AGENDA
City of Dallas Planning Commission
TUESDAY, September 13, 2022 - 7:00 p.m.
City Hall Council Chambers
187 SE Court Street

**CITY OF DALLAS
PLANNING COMMISSION
STAFF REPORT**

Application Type: Detailed Development Plan & Preliminary Subdivision
Owner: Meadows Investment, LLC
Applicant: Meadows Investments LLC
Location: Barberry Mixed Use Master Plan Node

CITY OF DALLAS
NOTICE OF PUBLIC HEARING
Detailed Development Plan #MP-22-03

1 MAJOR COLLECTOR - BARBERRY NODE - 71.0' R.O.W.
SCALE: NTS

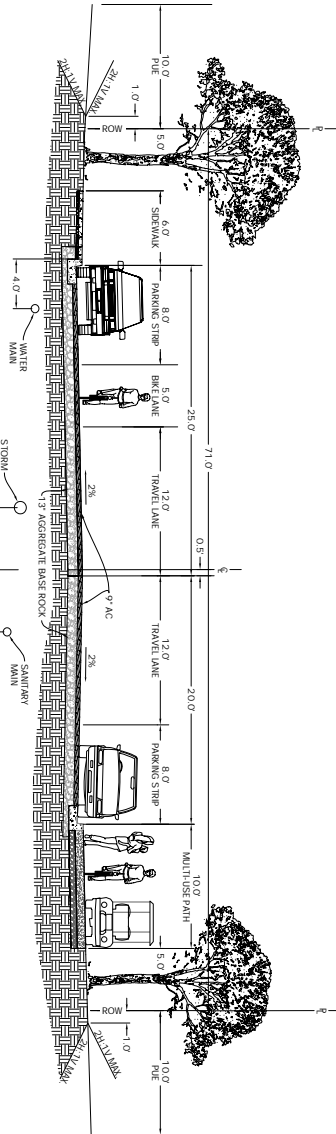
Barberrry Ave: The Applicant's proposed modified street section for Barberrry Ave is illustrated on the Applicant's Exhibit D, Detail 1. Public works has approved this modified street cross-section for Barberrry Avenue.

2 MINOR COLLECTOR - BARBERRY NODE - 61.0' R.O.W.
SCALE: NTS

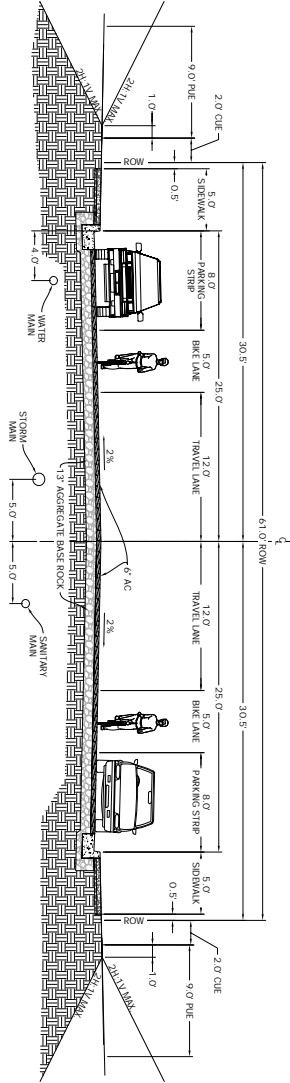
The Applicant's proposed modified street section for Hankel Street is illustrated on the Applicant's Exhibit D, Detail 2. This modified section has the same roadway width (50 feet) and lane configuration as the City standard; the only difference is the placement of the sidewalk abutting the back of the curb and the removal of the 3.5-foot-wide planter strip. The right-of-way width behind the sidewalk is reduced from 1 foot to 0.5 feet. A 2.0-foot-wide City utility easement (CUE) is provided for placement of City utilities (storm drain and sanitary sewer lateral clean-outs, fire hydrants, water air-vacuum relief valves and enclosures, etc.) adjacent to the right-of-way, and the public utility easement outside of the City CUE. Public works has approved this modified street cross-section for Hankel Street. The Applicant request the Planning Commission's approval for utilization of this modified section for the remaining portions of Hankel Street with the Barberrry Node.

2 LOCAL STREET - NO L.S. ON SOUTH SIDE - 1/2 street + 7.5 feet - 28' R.O.W.
SCALE: NTS

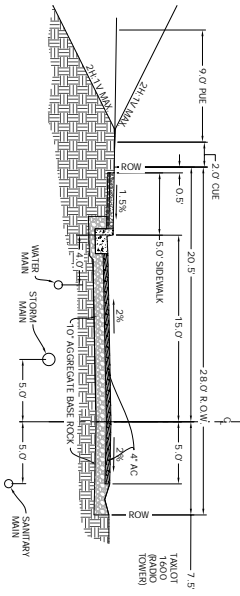
The Applicant proposed a "half-street +7.5 feet", which the "half-street" resembles the other proposed modified local street cross-section and which provides a 20-foot-wide paved vehicle roadway and a 2.5-foot-wide ditch, with no parking allowed. The proposed section is illustrated on the Applicant's Detail 2, Exhibit E. To provide a more "complete" street section, in lieu of the 2.5-foot-wide ditch, a curb and gutter section would be provided such that there is a 20-foot-wide drivable surface between curbs, and 0.5 feet behind the northerly curb for property pin placement, with an overall right-of-way width of 26.5. This will aide in trying to keep the centerline alignment of Boysenberry Ave. such that the two taxlots to the west of the property can be potentially successfully redeveloped, with the centerline being placed as close as feasible to the lot lines that separates these two taxlots (Taxlots 3300 and 3400).

2 LOCAL STREET - NO L.S. ON SOUTH SIDE - 1/2 street + 7.5 feet - 28' R.O.W.
SCALE: NTS

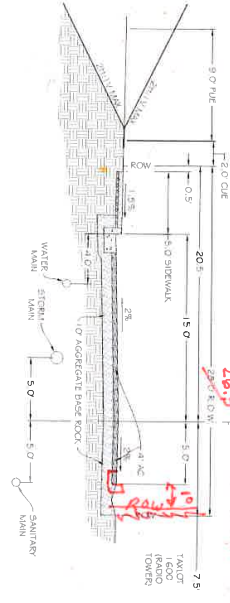
Planning staff do not support the proposed half-street abutting the radio tower property, designated SE Boysenberry Avenue in applicant's plans. There is nothing in Code allowing half-street development, and where exceptions have been allowed in the past it was abutting sites with near-term development potential; in this case, there is nothing in the record to indicate that the radio tower property will be redeveloped anytime in the foreseeable future. Therefore, if the development is approved by the Planning Commission, a recommended condition of approval should require this section to be constructed as a local street with 30 feet curb-to-curb, and 5 foot sidewalk and landscape strip on the south side. The additional 4,000 square feet of pavement this requires, which would be presumed to accommodate an additional 28 on-street parking spaces, can be found to be roughly proportionate to the impact of 173 new dwellings, being 23 square feet of pavement per dwelling.

Also attached is a marked-up cross-section of Boysenberry Ave along the radio station property on Detail 2 of Exhibit E. I will get you a revised Exhibit E showing the changes by the end of the day.

- d) The construction plans shall include the location of street trees, consistent with DDC.3.2.040.
- e) The construction plans shall show the full length of SE Boysenberry Avenue to have a curb to curb paved width of 30 feet, with a 5 foot sidewalk and landscape strip on the south side.
- f) The construction plans shall show the remaining local streets developed to criteria width with a 50 foot right-of-way.
